CITY OF ALBUQUERQUE

RE: **Tierra Serena (Glendesto) Subdivision**
Revised Grading Plan Stamp Date: 1/23/18
Certification Dated: 6/11/18
Hydrology File: B18D020

Based on your submittal received on 6/11/18, the Engineer's Certification cannot be accepted for pad certifications until the following are completed:

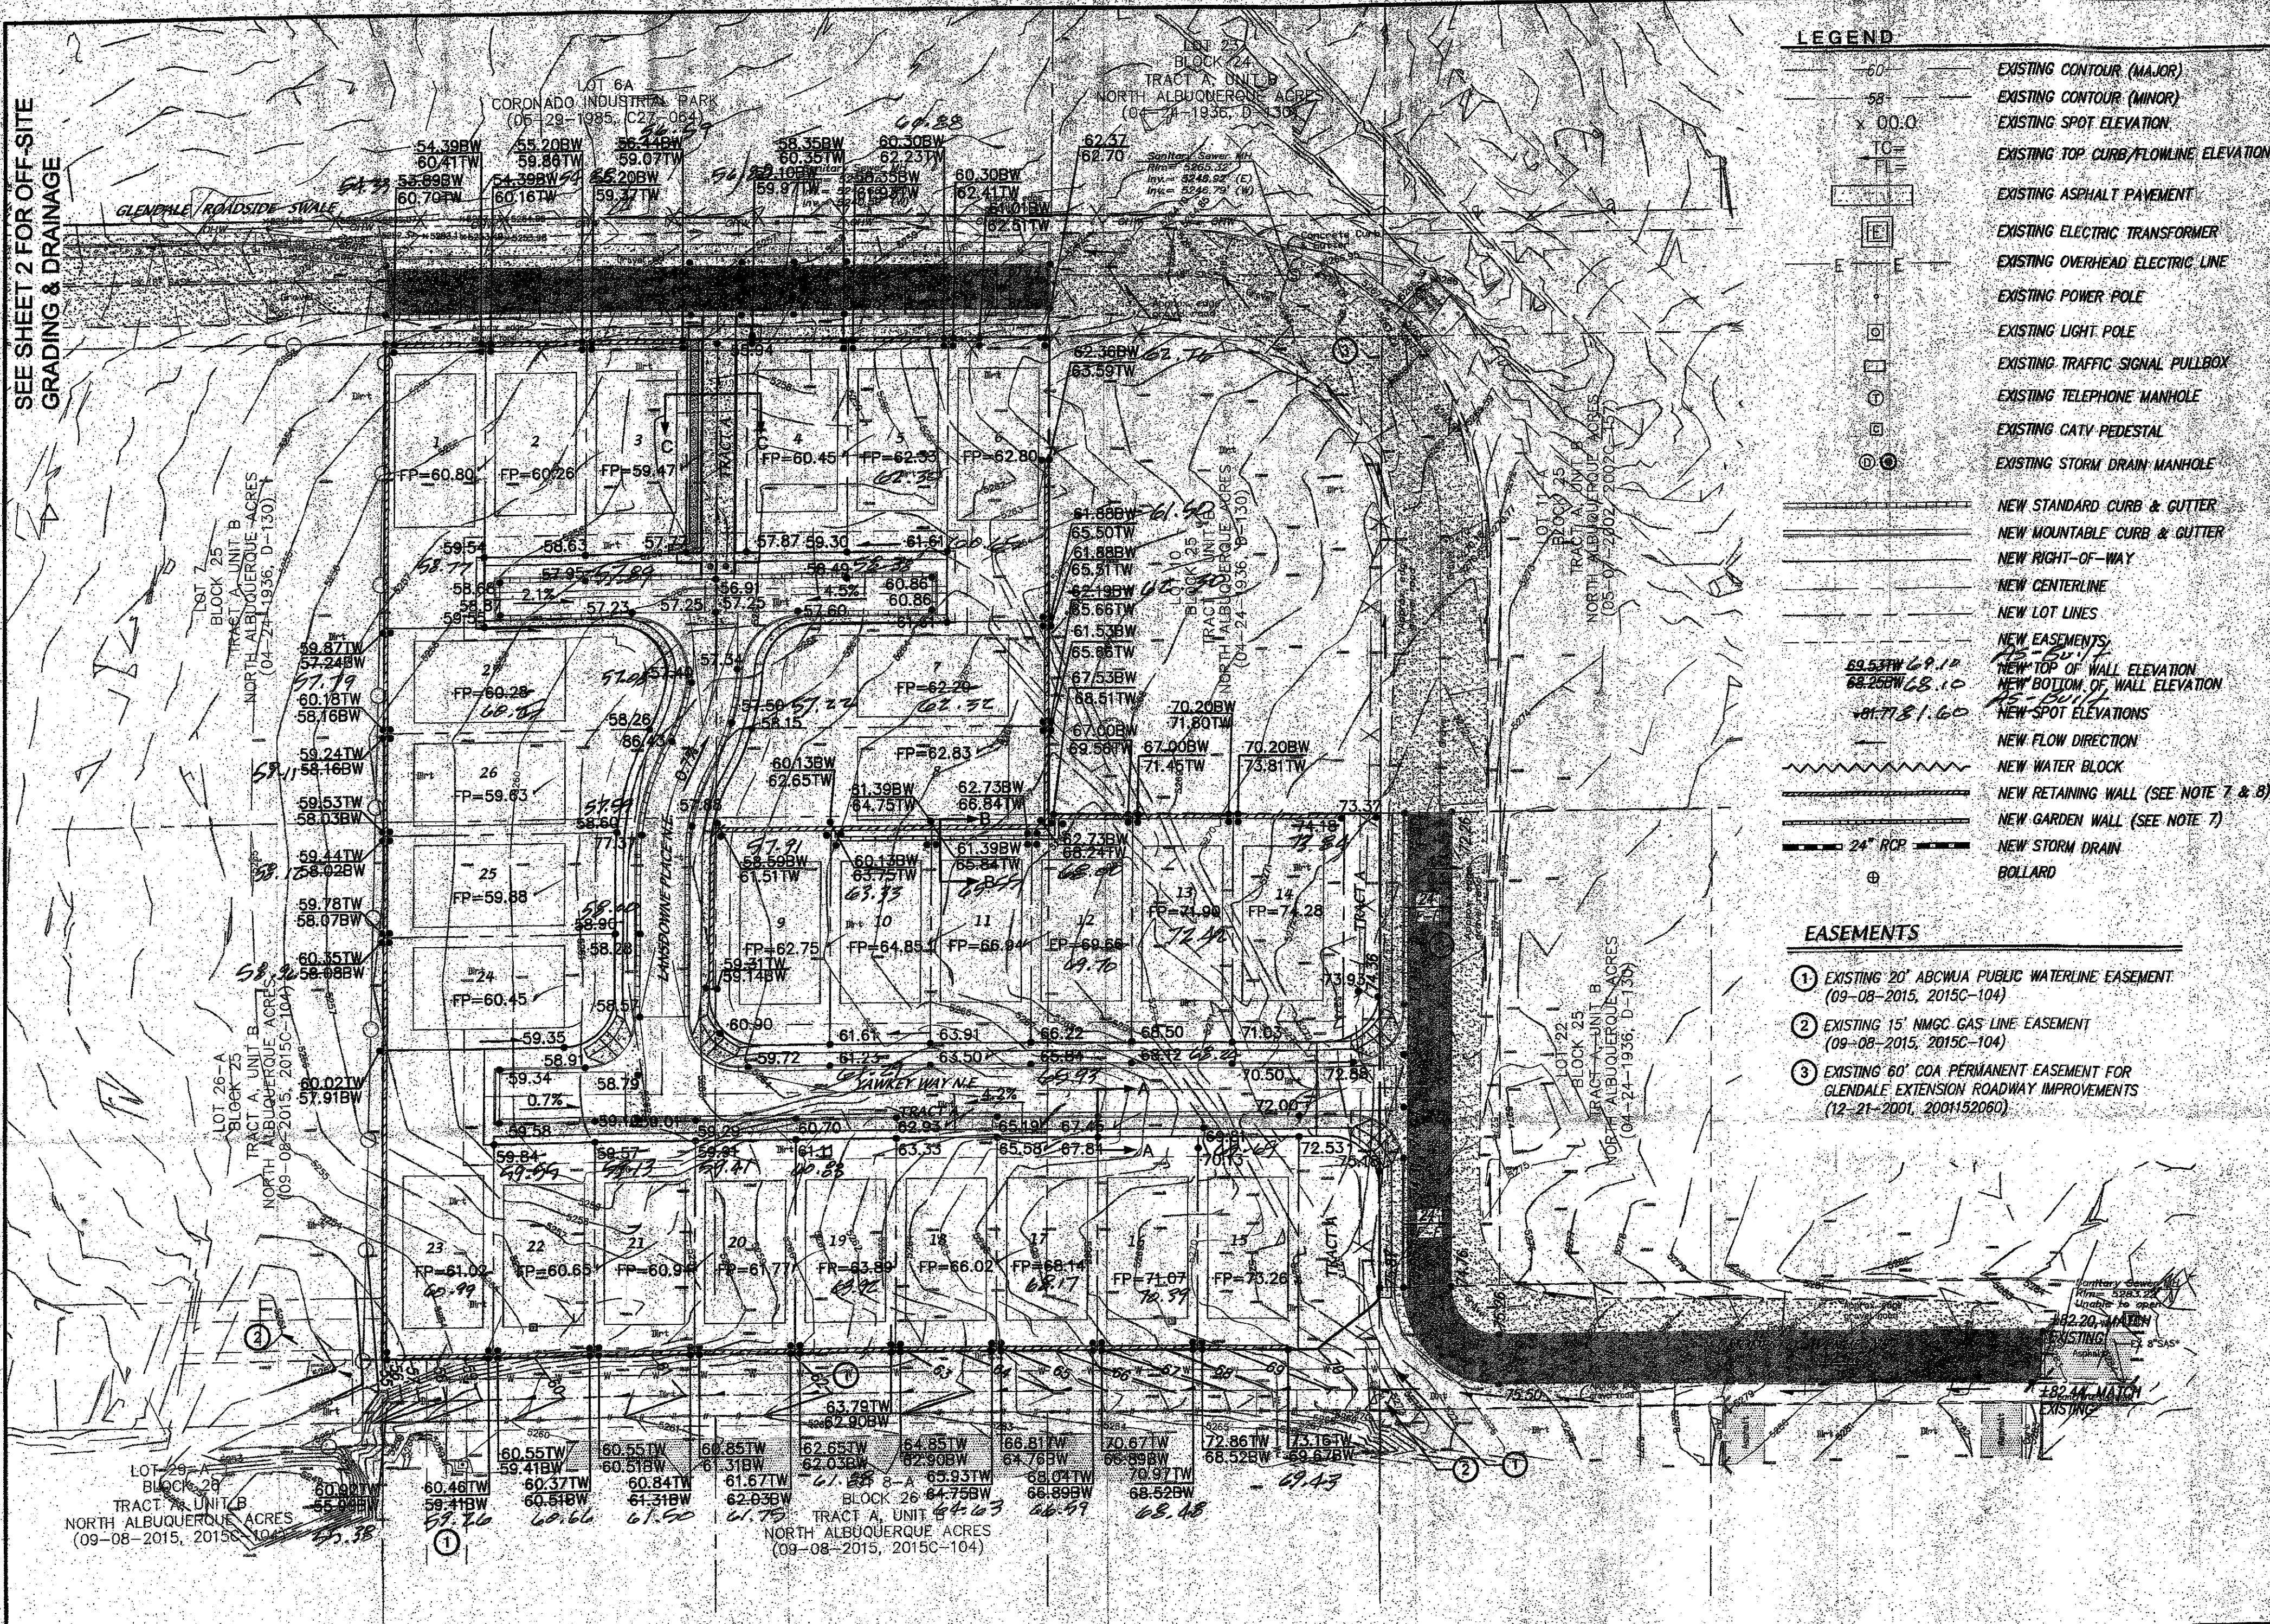
1. The following as-built information is deficient:
 - a. Pad elevations (Lot 14)
 - b. Property corner elevations at each lot
 - c. Horizontal and vertical data for retaining walls (top of wall and bottom of wall)
2. Additional survey showing flow paths and drainage features need to also be obtained as applicable to the individual lot.
3. The concrete washout on Lot 23 needs to be removed prior to certifying Lot 23.
4. The parking lot needs to be removed prior to certifying Lot 14.

5. All survey data required per the DPM Ch 22.7: *Engineer's Certification Checklist for Subdivision* will need to be provided for Lots 5, 6, and 13.
6. The downstream storm water conveyance must be complete.
7. The water and gas easement behind lots 15-23 needs to be restored. Fill placed against the wood fence needs to be removed and this area needs to be reseeded and stabilized against erosion with check dams and gravel mulch.
8. All other offsite areas distributed as part of this project need to be restored and reseeded as well.
9. Additional comments can be expected at the time of ROFG, depending on future conditions at this site.
